PROPOSED DEVELOPMENTS AT
5-6 HIGH STREET, CLEATOR MOOR
CA25 5BQ FOR HARRY BHAKER

EXISTING AND PROPOSED
ROOF PLANS

Drg. No. 2367/10 'A' Date NOV 23

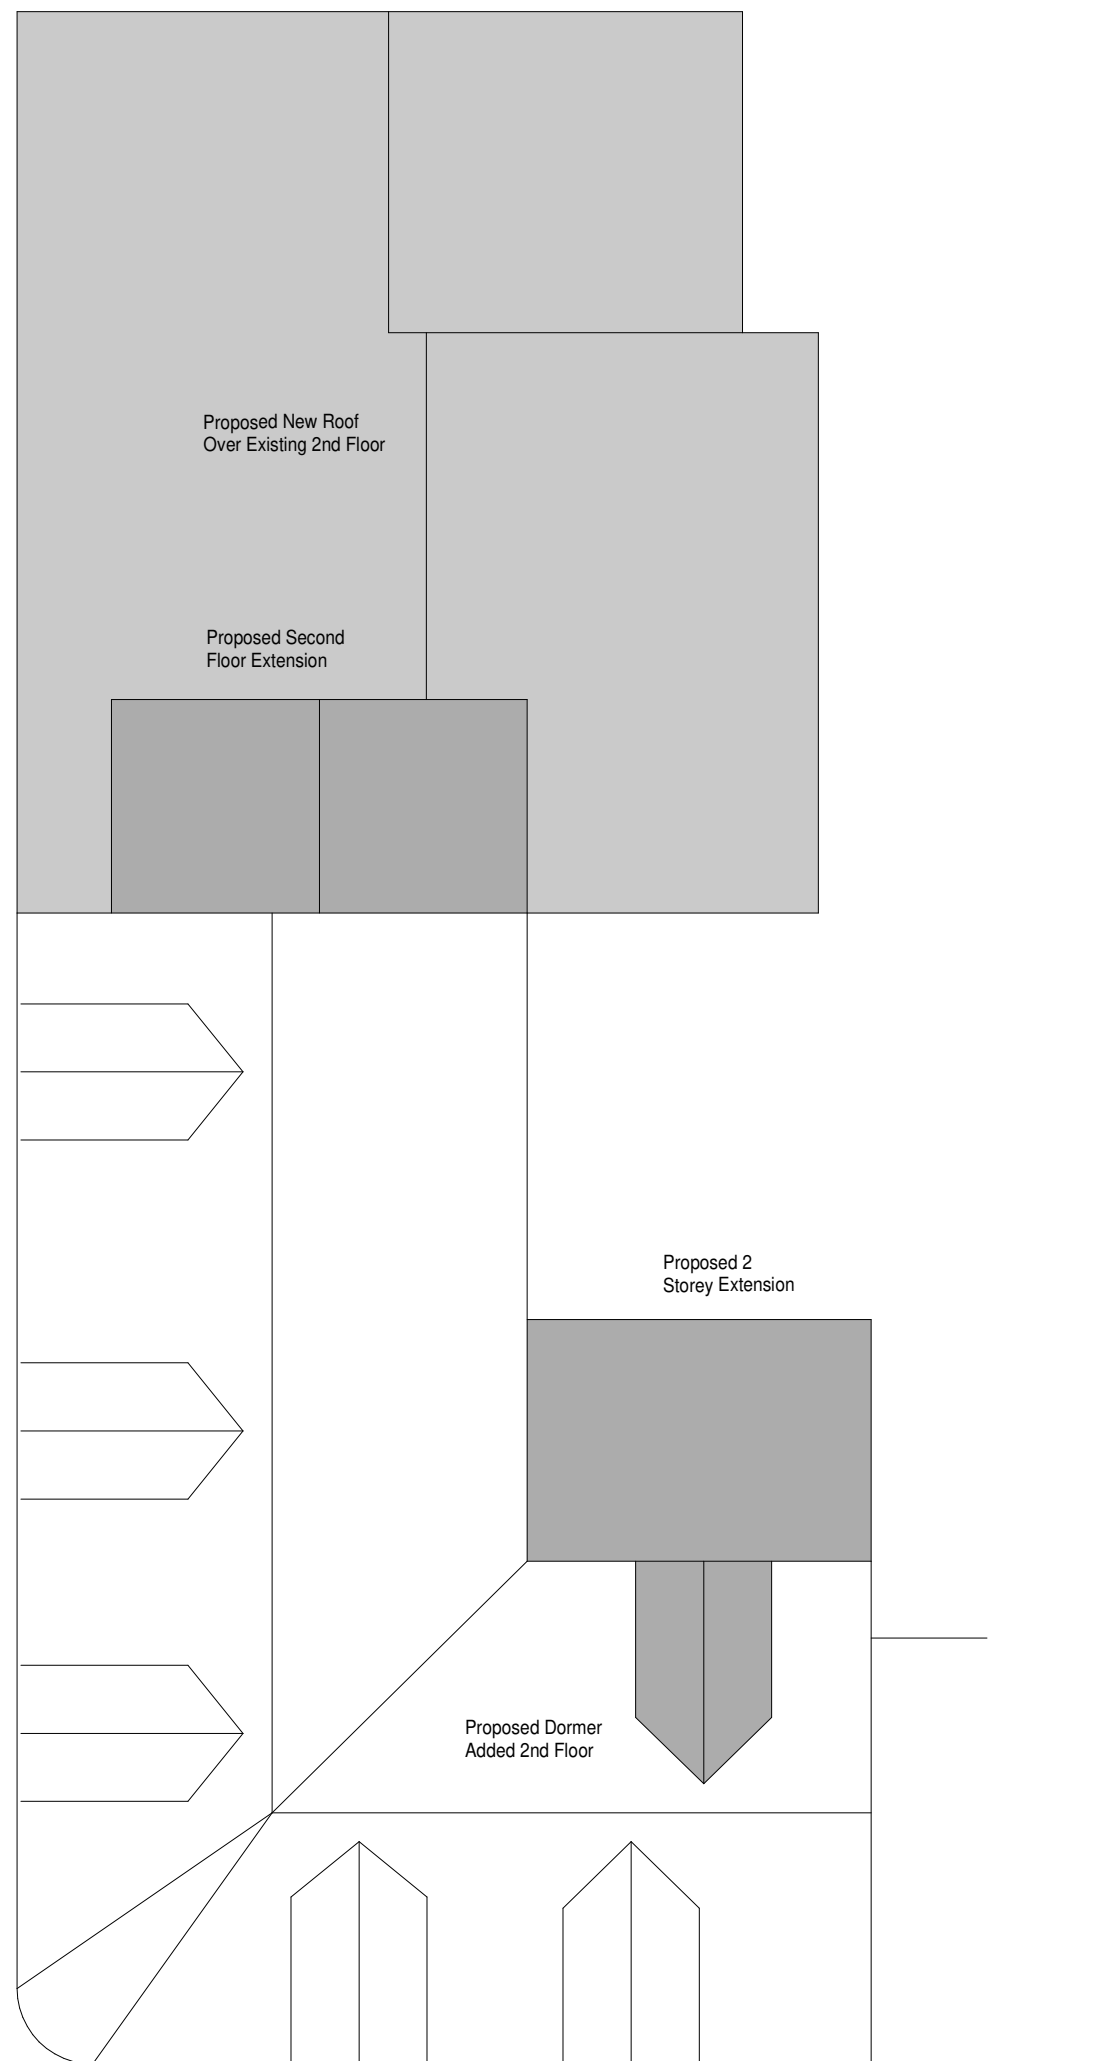
REV 'A' REVISED TO SUIT LPA COMMENTS 06-02-24
